# **PLANNING COMMISSION AGENDA REPORT**

**SUBJECT:** APPEAL OF THE PLANNING DIVISION'S ZONING APPROVAL TO CONSTRUCT ADDITIONS TO THE FIRST AND SECOND STORY OF AN EXISTING TWO-STORY RESIDENCE.

An appeal of the Planning Division's Zoning Approval (BC 13-00844) to allow construction of first and second story additions to an existing two-story residence at 3384 Wimbledon Way, subject to conditions of approval. The appellant claims that the project impacts the privacy of the adjacent home directly behind (east) of the subject property and that the project does not comply with the City's Residential Design Guidelines, including, but not limited to, those concerning privacy, coverage, second-story designs and window placement.

### ***Zoning Approval BC 13-00844***

PROPOSED FIRST FLOOR PLAN

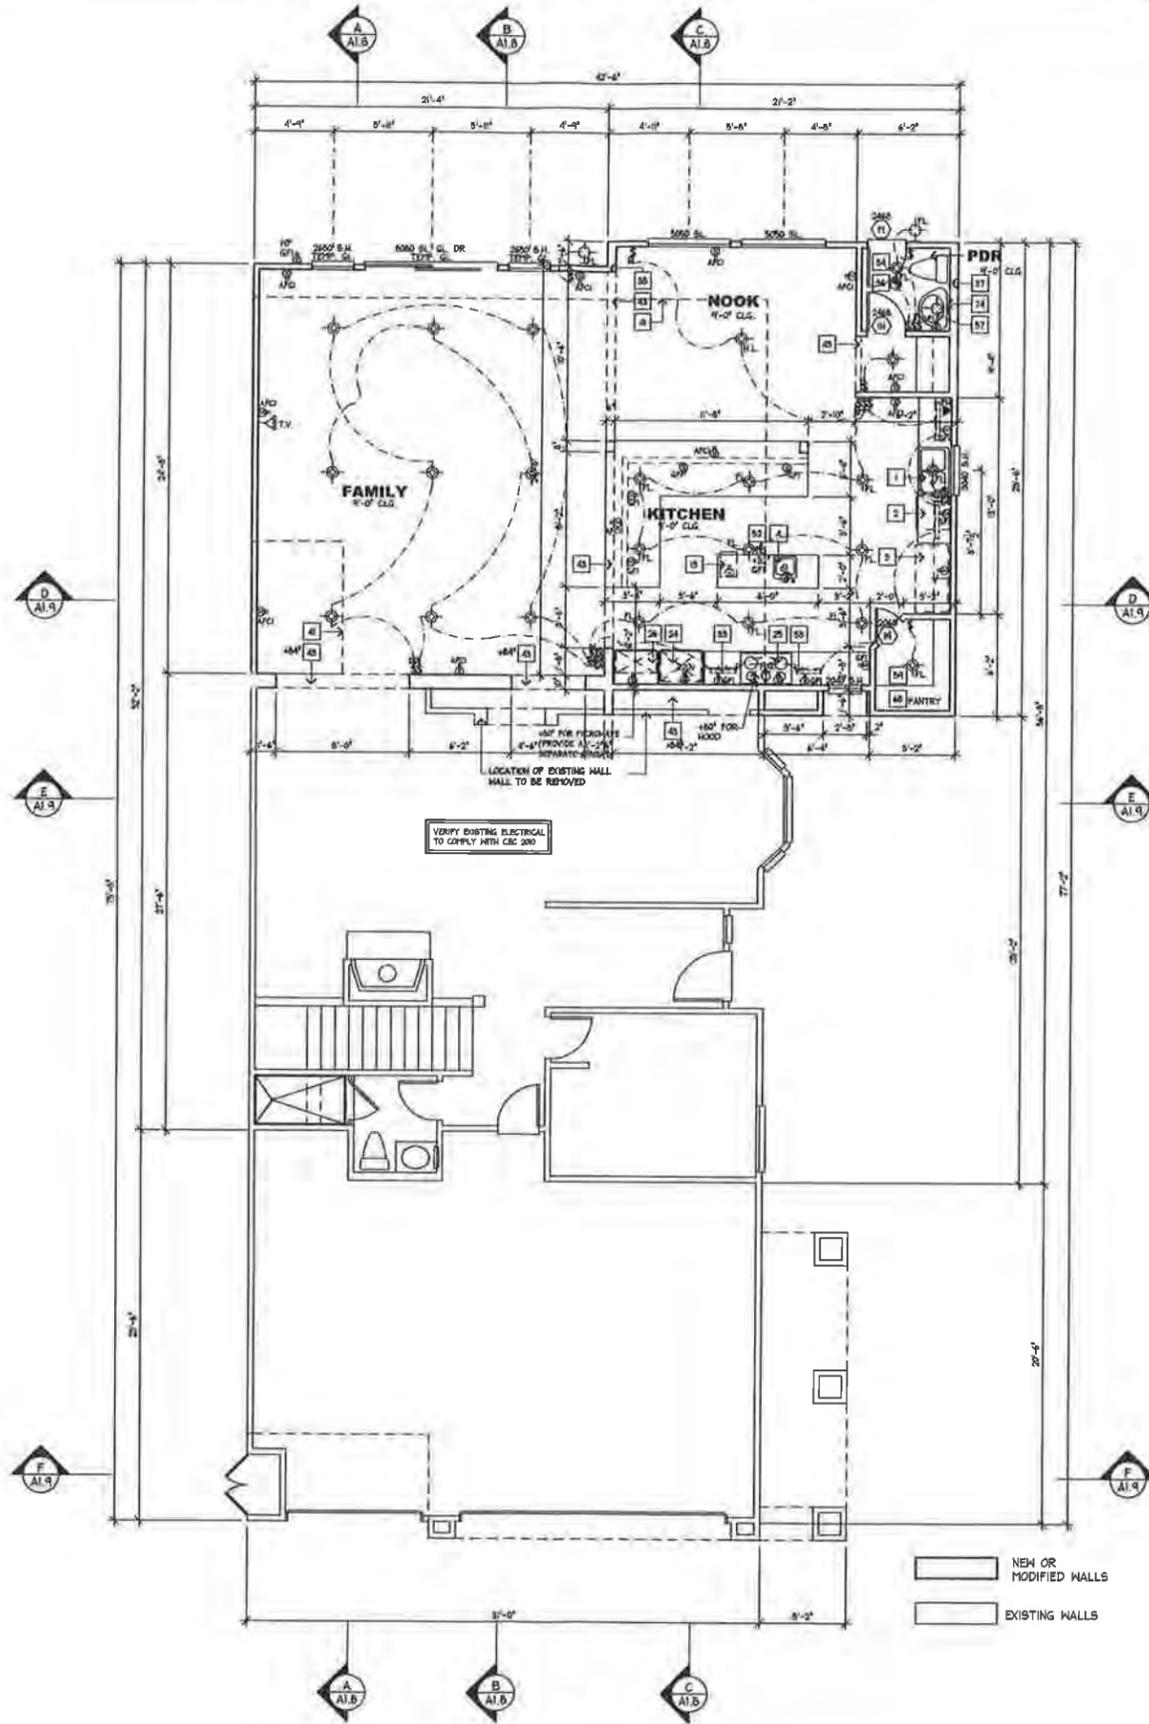
The second story design of the addition complies with the requirements of the Guidelines. The addition is designed with off-sets on all elevations to avoid a boxy appearance from the street and neighboring views. The side and rear elevations indicate that the exterior will be stucco with sand finish to match the existing elevations. The second-story floor area is 81 percent of the first-story floor area including the attached garage. The second story floor area includes an existing deck.

The second story addition incorporates offsets along the north side. The south façade includes a gabled roof design, a modulated first floor addition, existing bay windows, and projections that add visual interest. Because the residence was originally constructed as a zero lot line home, there are no windows existing along the south side. The second story off-set design provides both a vertical and horizontal plane break along the north (side) façade and employs a niche for the code required egress windows. These windows face one another and views to the adjacent property would be at an angle. The new north facing windows are indicated as frosted glass to ensure the neighbor's privacy. The roof design continues the original form and would have a minimal effect on the light and air provided to the adjacent property. The design of the second story addition takes into consideration the light, air and privacy of the adjacent property. Attachment 4-8 provide various plans and elevations showing the design features described in this report; they include a site plan, floor plans for the first and second floor, side and rear elevation.

**PROPOSED SECOND FLOOR PLAN** SCALE 1/8"=1'-0"

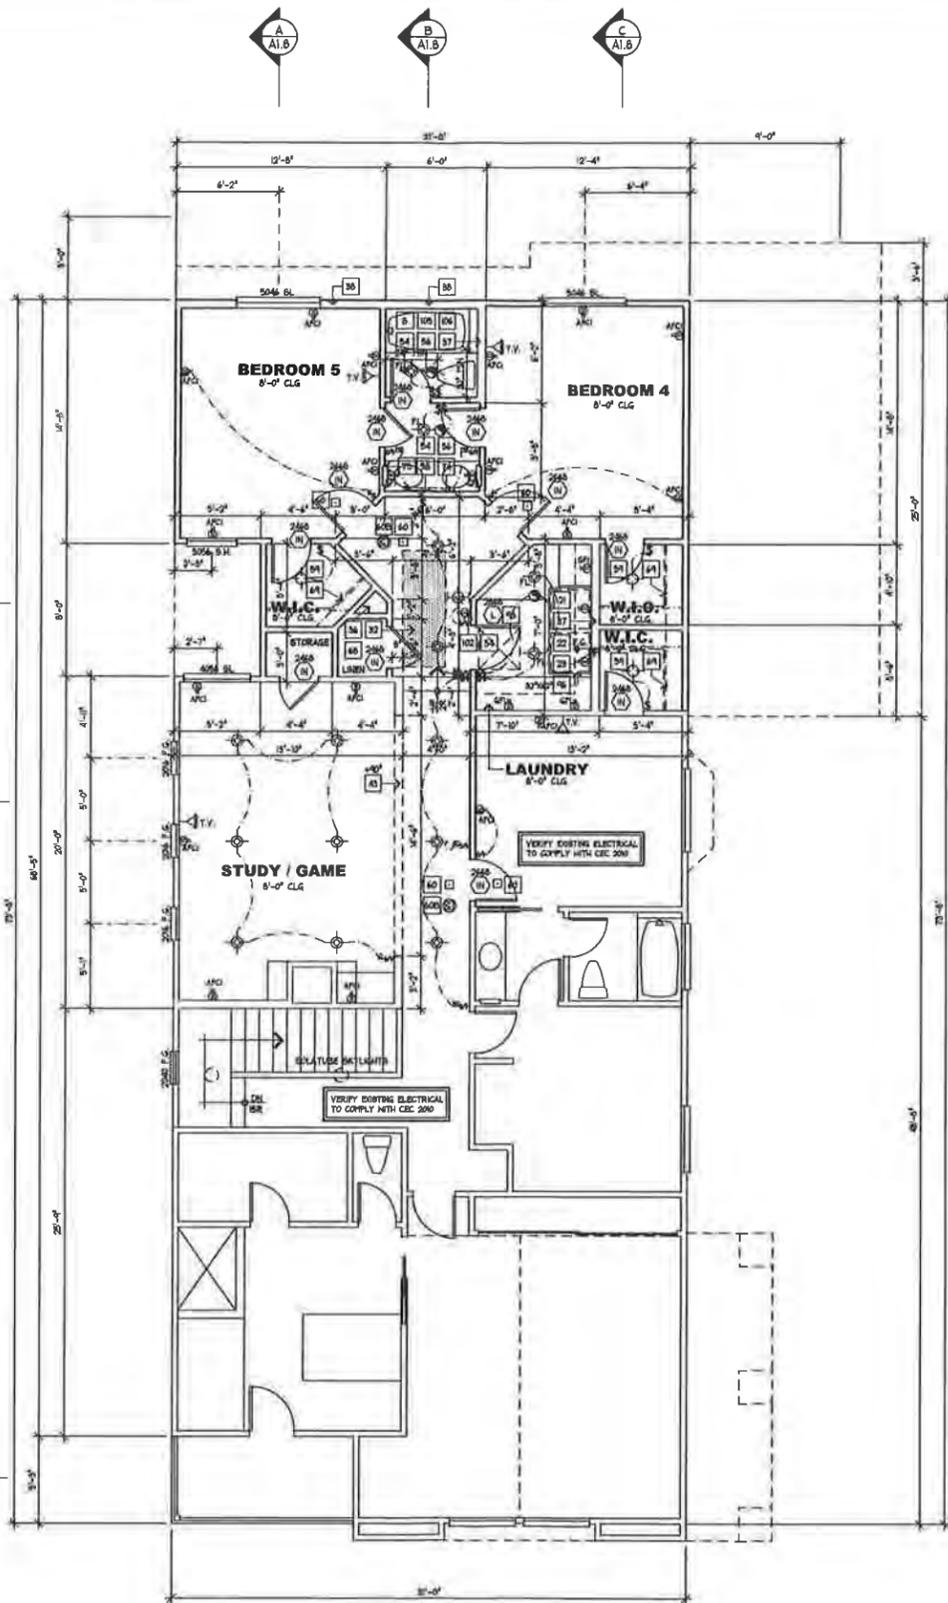
The second-story windows that are necessary to comply with Building and Safety standards are designed within an off-set niche to minimize direct views onto the adjacent property. In addition, a 28-foot setback from the rear property line is provided, where a minimum 20-foot rear yard setback is required.

WHEREAS, the Planning Division approved the application with a requirement for installation of frosted glass for second story north-facing windows and provided Official Public Notice of Zoning Approval on January 10, 2014; and

NEW EXTERIOR ELEVATIONS & ROOF PLAN

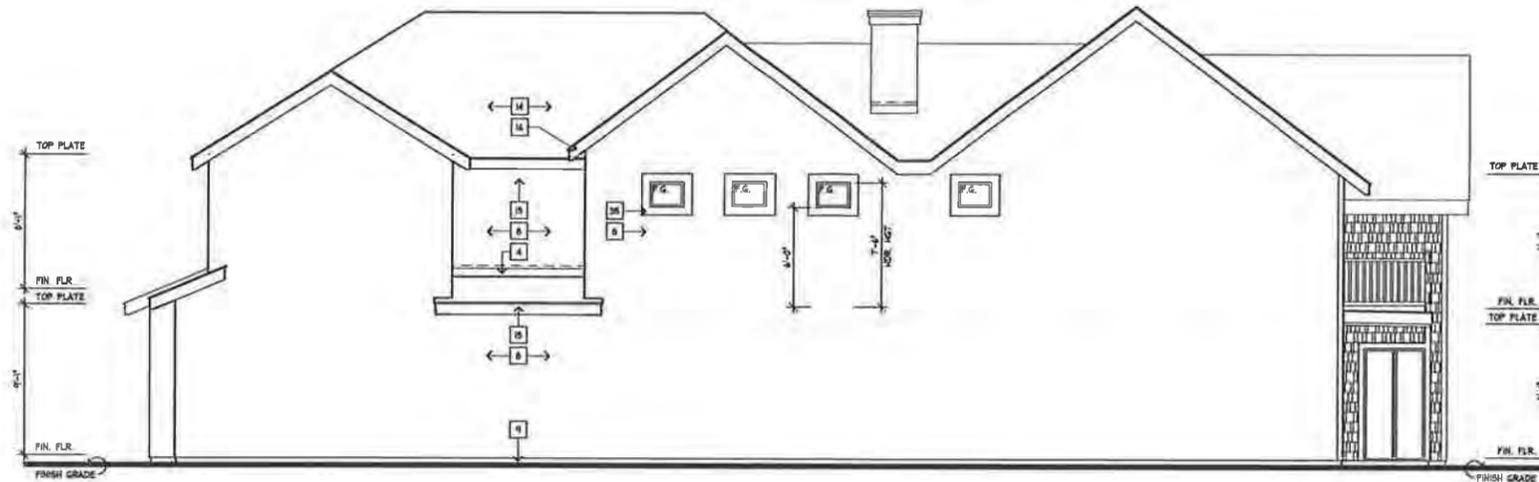
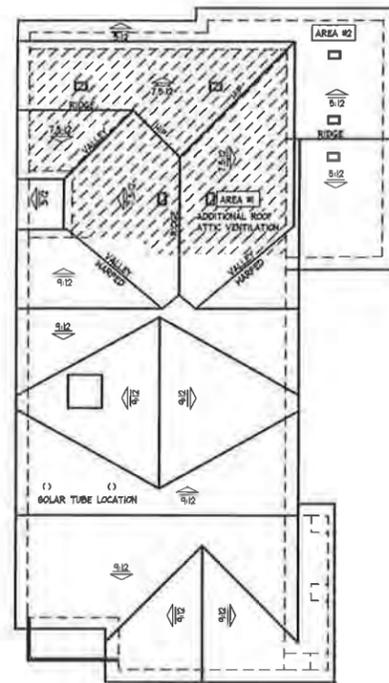
Architectural projections are provided along the south side of the building emphasizing the main entry to the residence and the bay window in the dining room. The varied roof forms provide a transition from the first floor to the second floor. The north side elevation incorporates an offset and break in the building plane for the new windows.

The roof is designed with multiple gables that reflect the original design and character of the home. The addition is lower in height than the existing second story and incorporates the same roof pitch as the original design.
